Client
LONDON DIOCESAN BOARD FOR SCHOOLS
Job
ST LUKE'S C of E SCHOOL

Drawing Title
PROPOSED LOWER GROUND FLOOR PLAN

Drg. No. 895 003 Rev. B

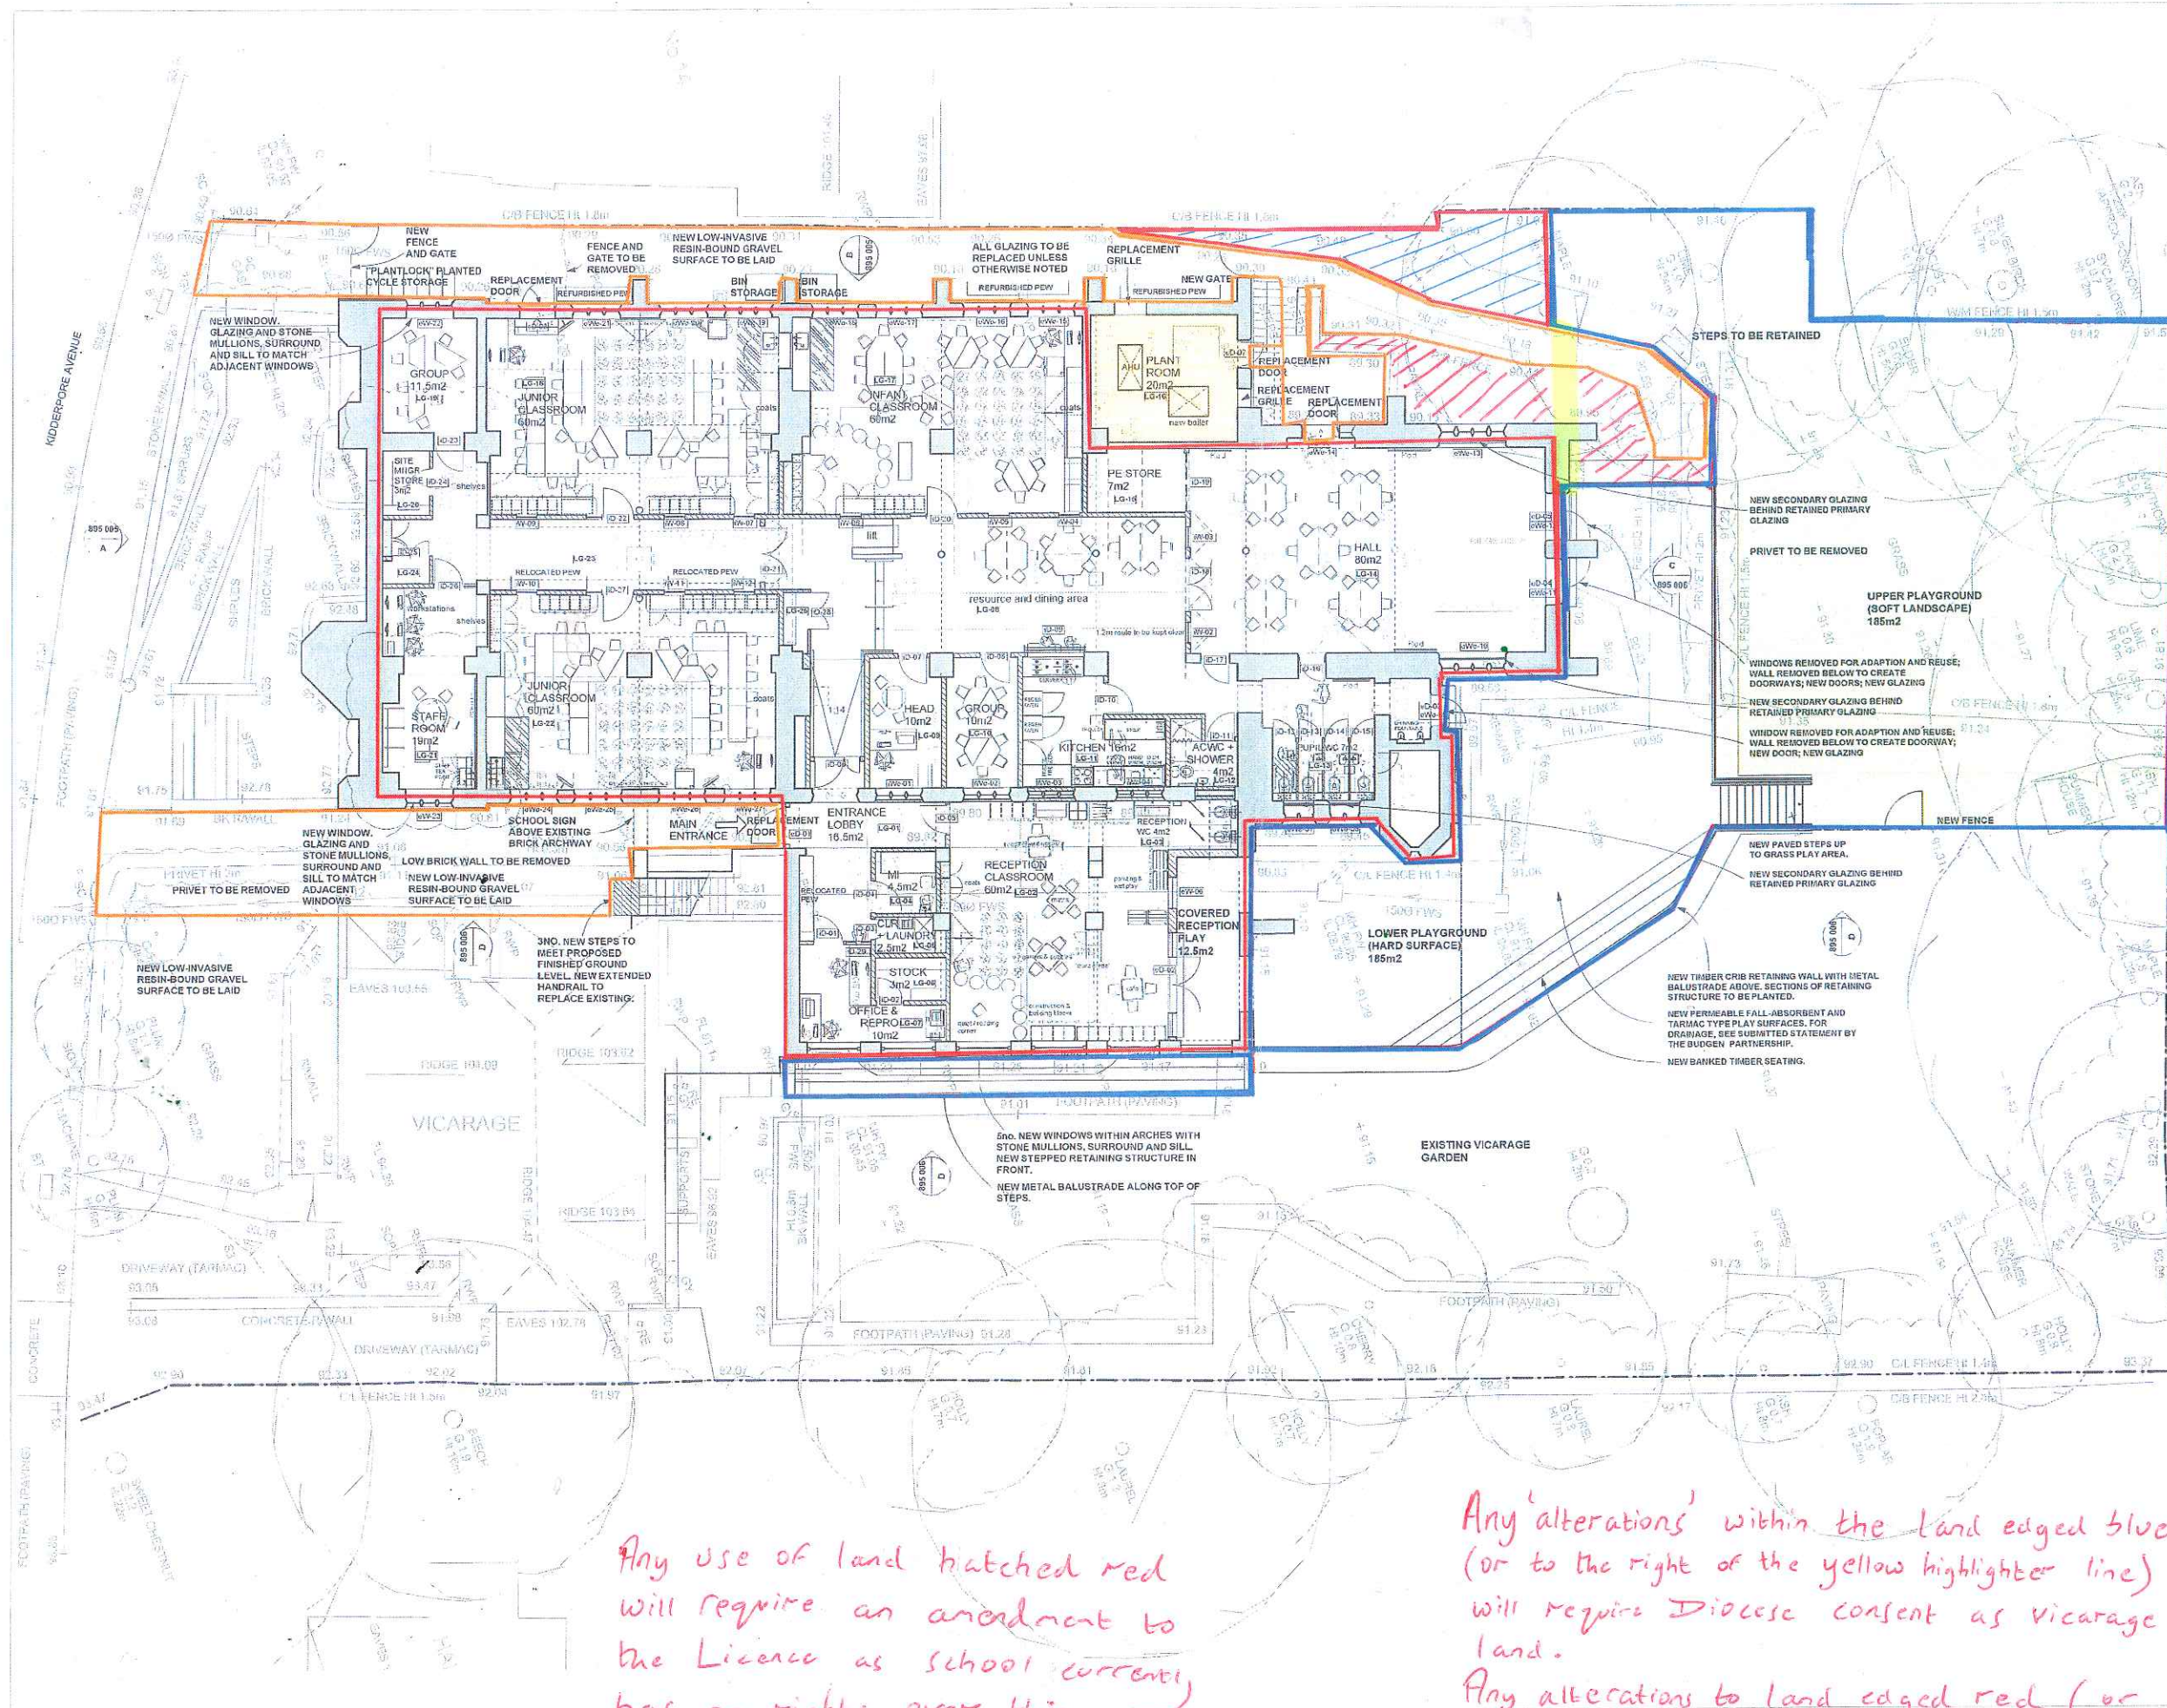
Any use of land hatched red will require an amendment to the Licence as school currently has no rights over this area.

Any 'alterations' within the land edged blue (or to the right of the yellow highlighter line) will require Diocese consent as vicarage land.

Any alterations to land edged red (or to left of highlighter) will require PCC consent as church land. Possibly also a Faculty.
